1966 Corvette: Service News: Wiring Diagrams for Breakerless Ignition Systems

Subject: Wiring Diagrams for Breakerless Ignition Systems

Model and Year: 1966 Passenger Cars

Date: November 1965 - Volume 37 - Number 10

Fig. 6—Breakerless Ignition System—Chevrolet, Chevelle & Chevy II

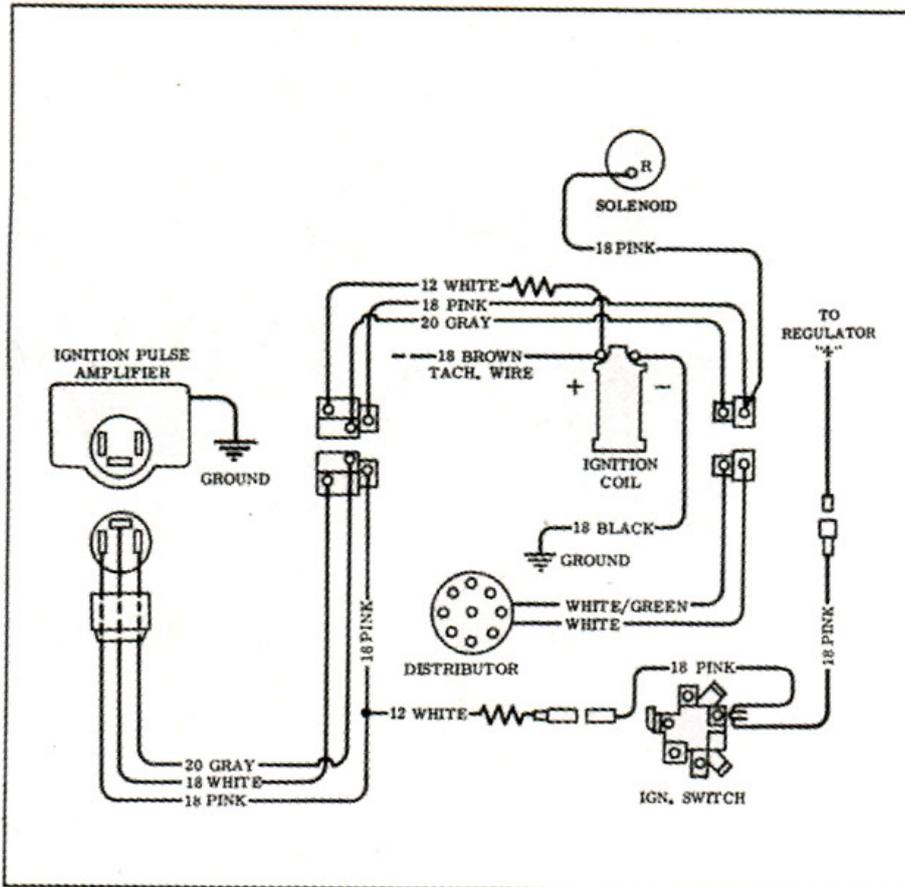
The following wiring diagrams for breakerless ignition systems superseded all other published diagrams for Chevrolet, Chevelle, Chevy II and Corvette.

The "12 white" is a calibrated resistance wire located on the negative side of the ignition coil on 1965 vehicles. However, in 1966 this resistance is placed on the positive side of the coil for added protection of the ignition pulse amplifier in case of accidentally grounding the ignition coil wire. At the present time, the above does not apply to trucks.
